Project Name: New Haven BRF 0183(1)

Structure Identification: TH 2, Bridge 10

The structural steel fabrication drawings associated with Items 506.56 Structural Steel, Curve Plate Girder, Item 900.645 Special Provision (Precast Concrete/Steel Composite Pier Cap), and Item 900.670 Special Provision (Metalizing of Structural Steel), has been reviewed and is being returned herewith.

Project: River Road, Bridge # 10, New Haven, VT
Project No. BRF 0183 (1)
CBSS Job: 645
Subject: Structural Steel Metalizing Procedure

DETAIL "WS1"
STIFF. WELD TERMINATION

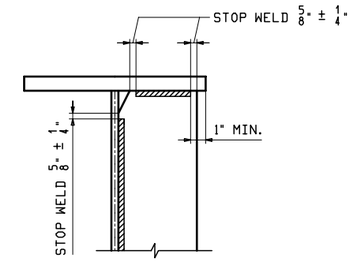
Why are these options? perhaps this should be WPS 470 for both of these without the other options

FRAMING PLAN

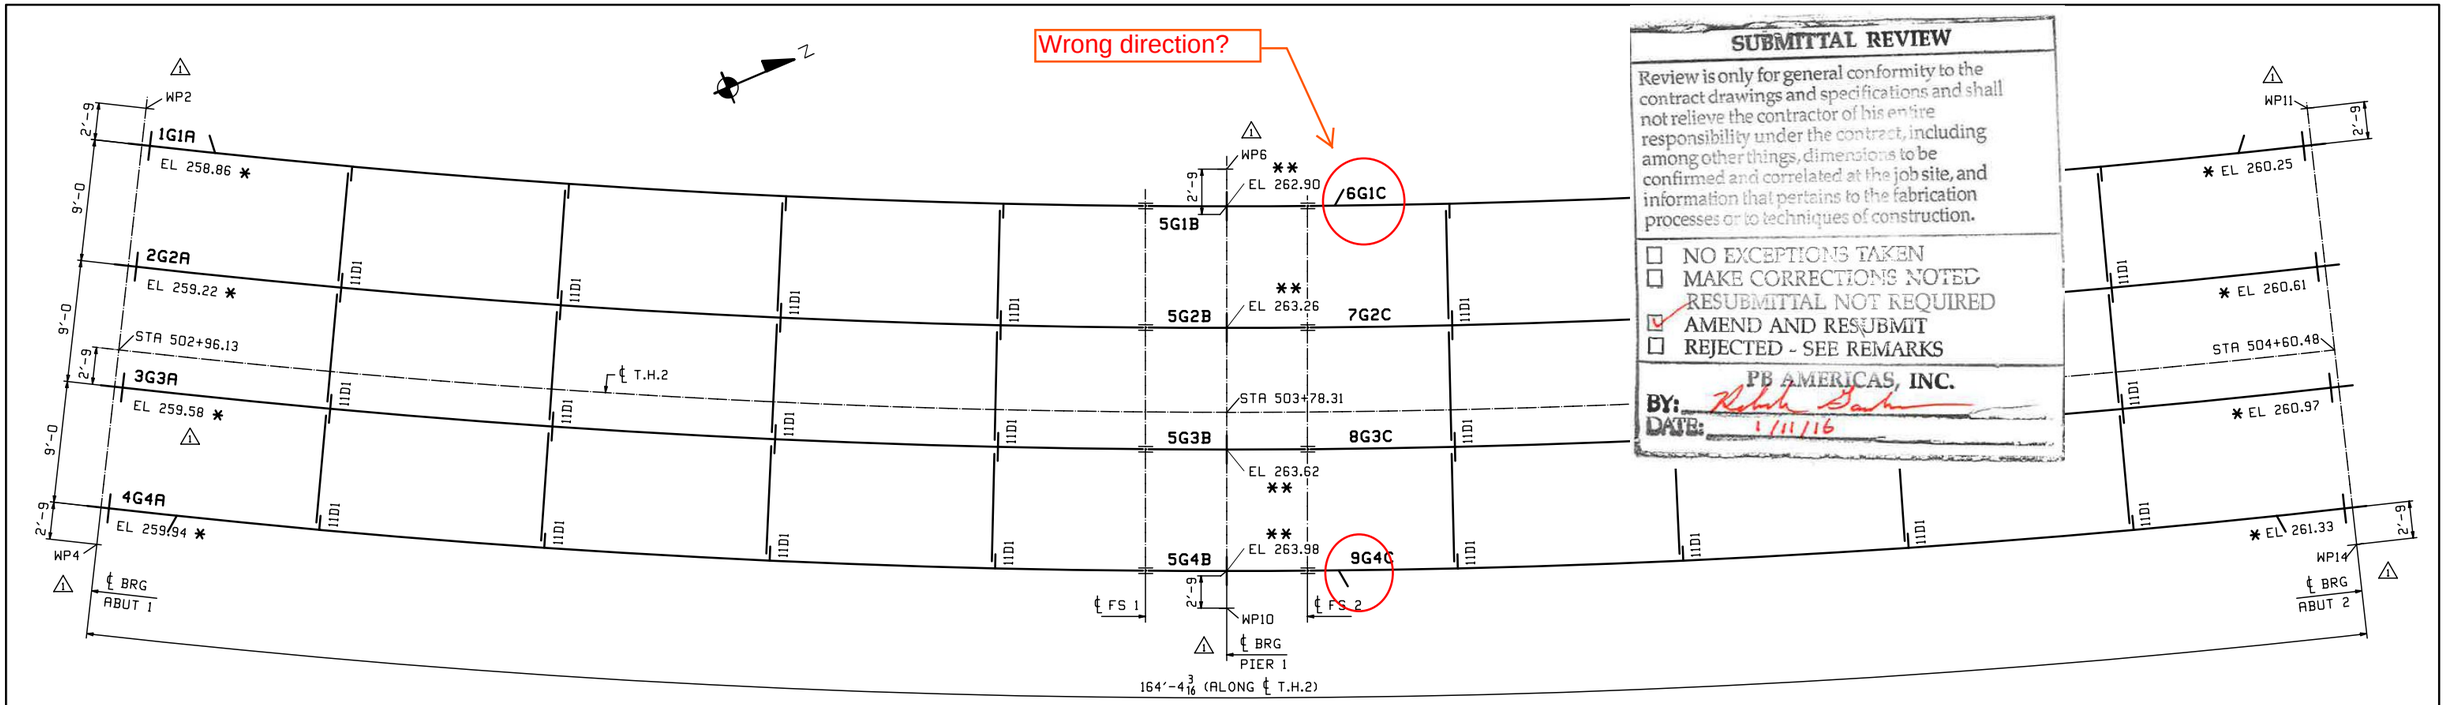
Wrong direction?

ELEV @ ABUT 1 (SHOWN)
ELEV @ ABUT 2 (SIMILAR)

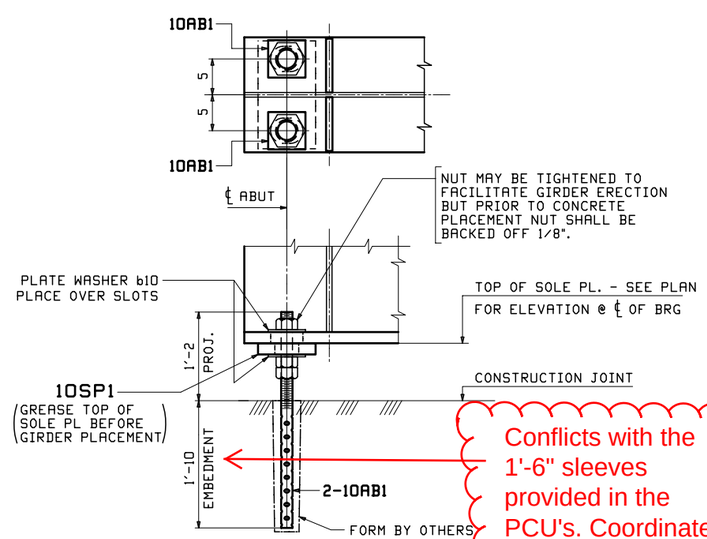
Conflicts with the 1'-6" sleeves provided in the PCU's. Coordinate with precaster.

CALCULATION PLAN

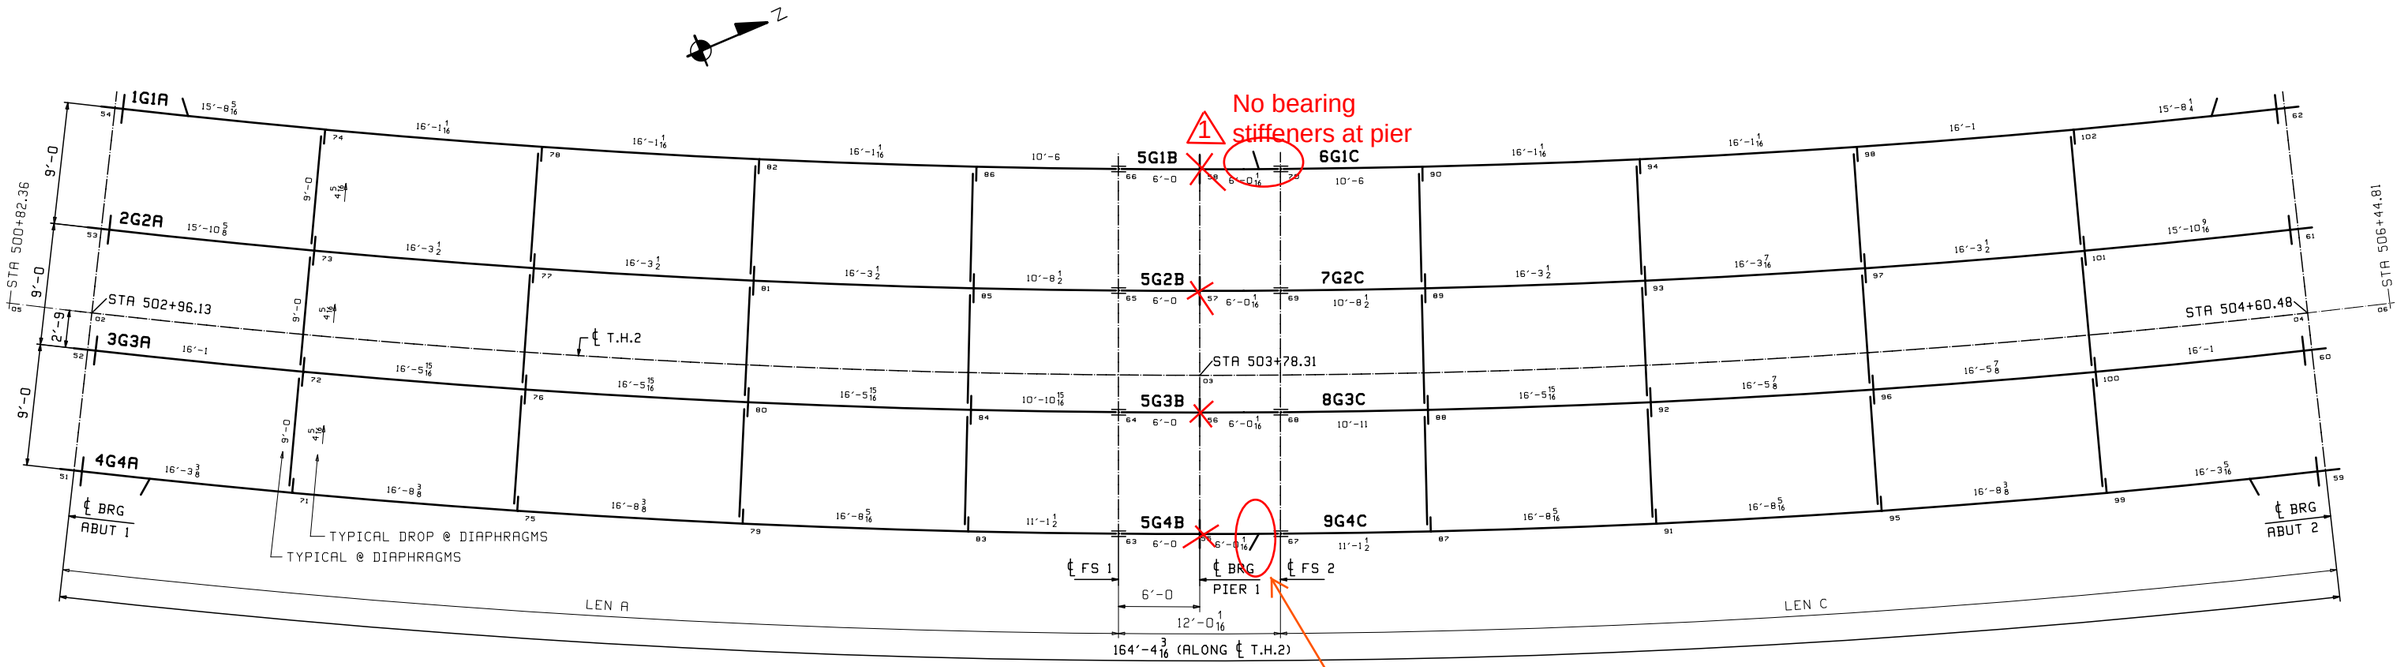
Drip bars on the wrong side of the connection??

SECTION D-D

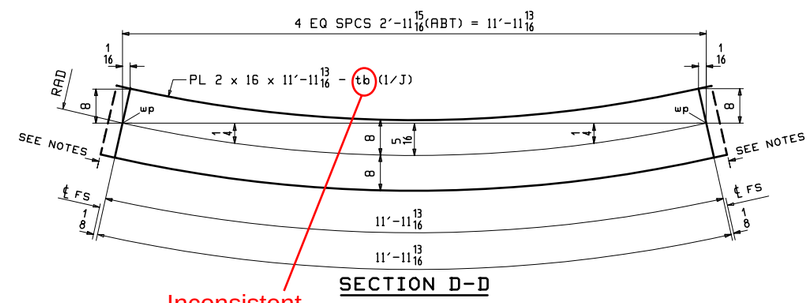
Inconsistent Mark

3 ~ DRIP BAR ~ x2d

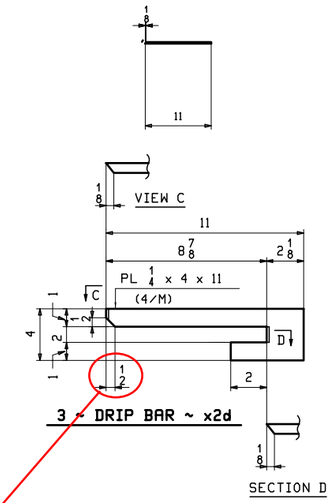
Note that flange to web weld leg size is 5/16". If anticipating tight fit, adjust size shown here.

ONE ~ GIRDER ~ 1G1A (DEV.)

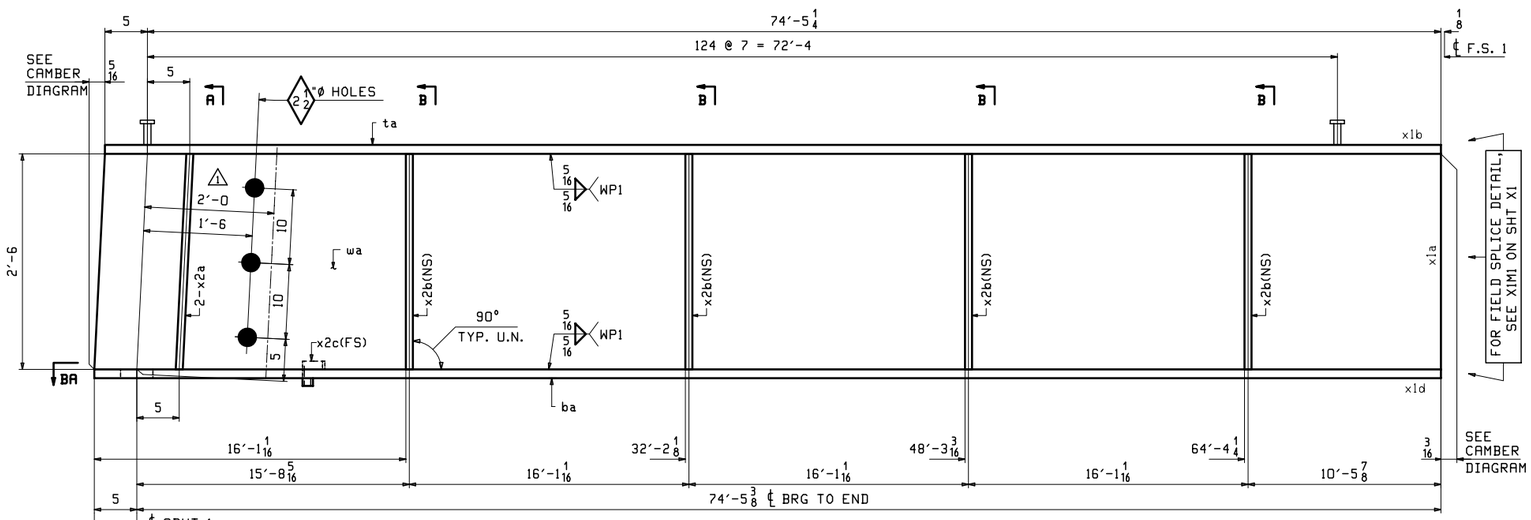
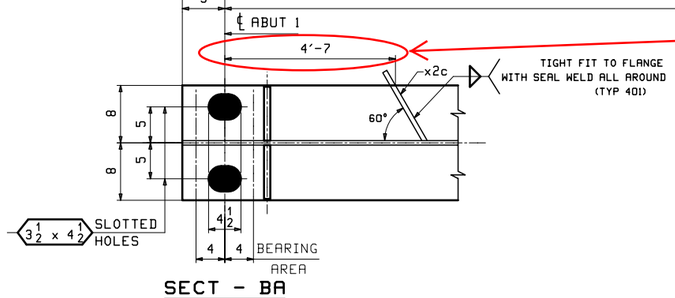
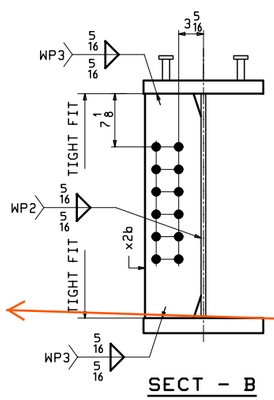
Leaves 2'-7" from face of abutment.
VTrans standard is 3' from face.

How are the shear studs to be attached?? Perhaps we need a note to say they will be welded with an automatically timed stud gun? or if they are welded with SMAW, they should be detailed to have a fillet weld all the way around the stud. (TYPICAL)

ONE ~ GIRDER ~ 6G1C (DEV.)

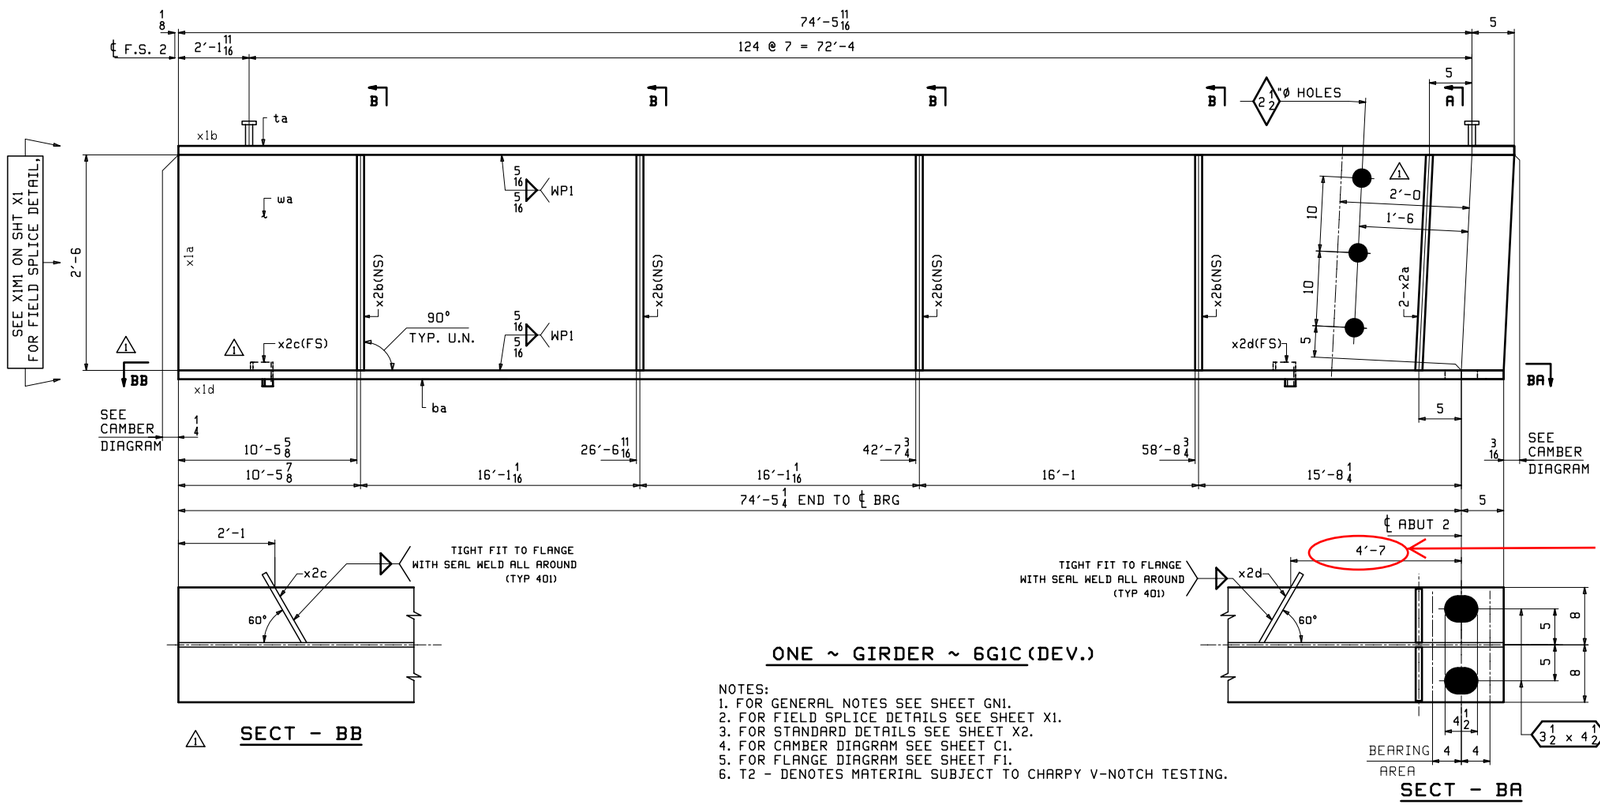
Leaves 2'-7" from face of abutment. VTrans standard is 3' from face.

ONE ~ GIRDER ~ 9G4C(DEV.)

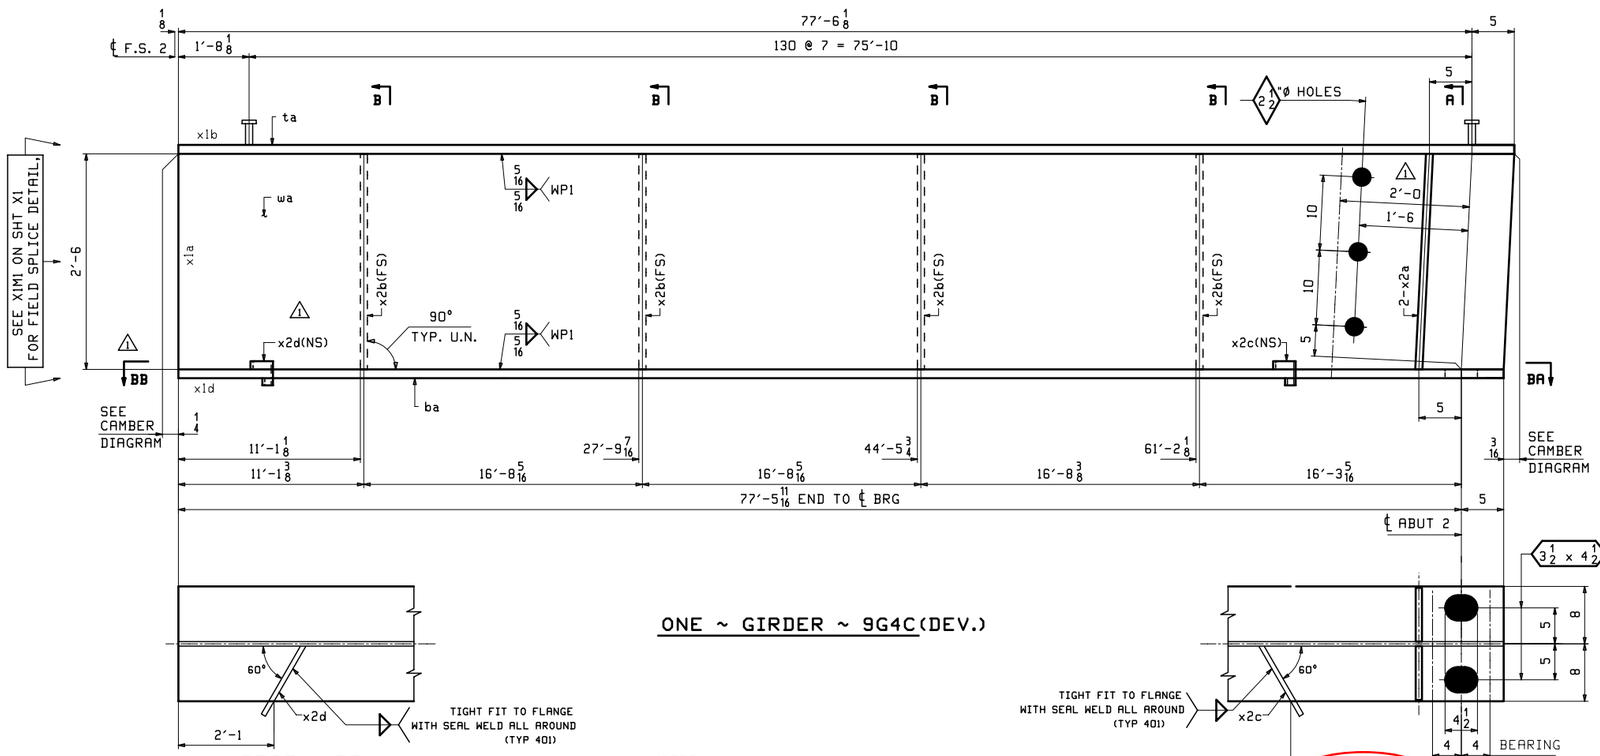
Leaves 2'-7" from face of abutment. VTrans standard is 3' from face.
